Authorized Field Change

AFC 11919

Subject: Engine ECM Failure — Export only

Model: CE, FBC, FE, RE, and SFC Bus / 4300, 4400, 7300, and 7400 Truck

Figure 1 Exhaust brake solenoid

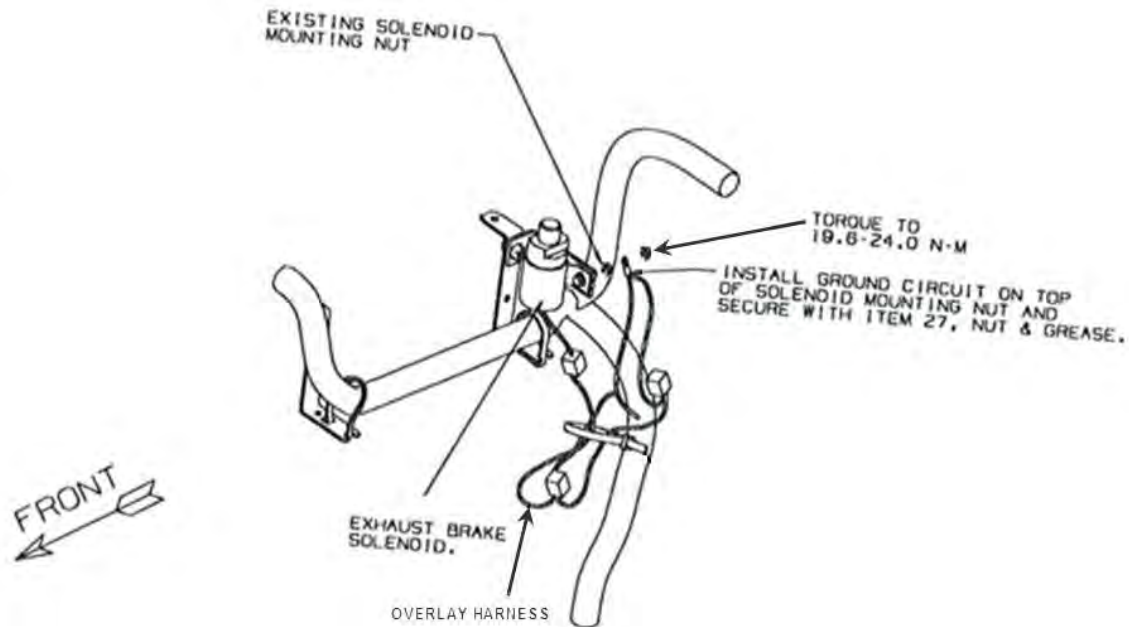
SERVICE PROCEDURE

Figure 2 Overlay harness

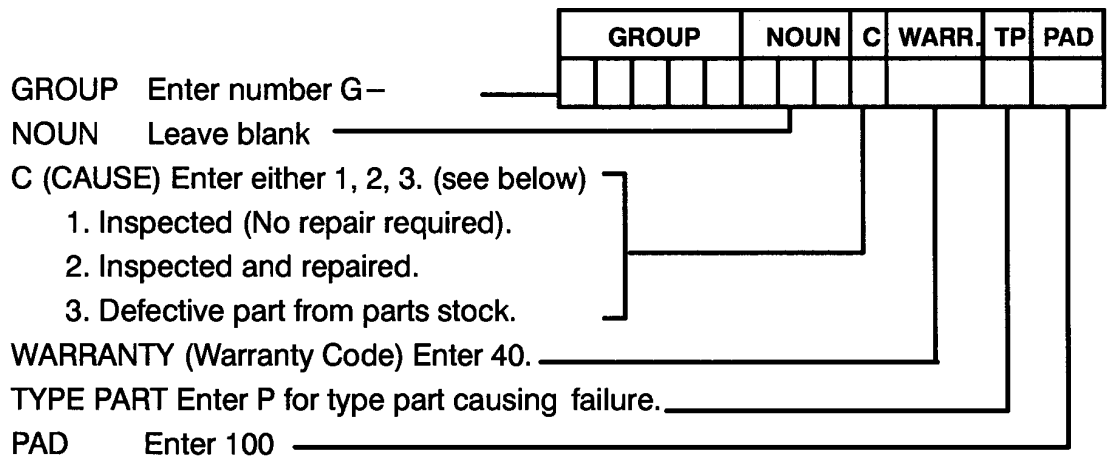
4. Plug the existing wire harness into the overlay harness that was added in step #3.
5. Remove the mounting bolt used to mount the exhaust brake solenoid.
6. Install new over lay harness ground eyelet over bolt.
7. Remove paint from engine block surface at tapped hole and attach ring terminal followed by applying dielectric grease over ring terminal.
8. Reinstall bolt and torque to 14.45 - 17.70 ft. lb. (19.6 - 24.0 N•m).
9. Route and clip overlay harness away from moving and hot components (See Figure 2, page 4).
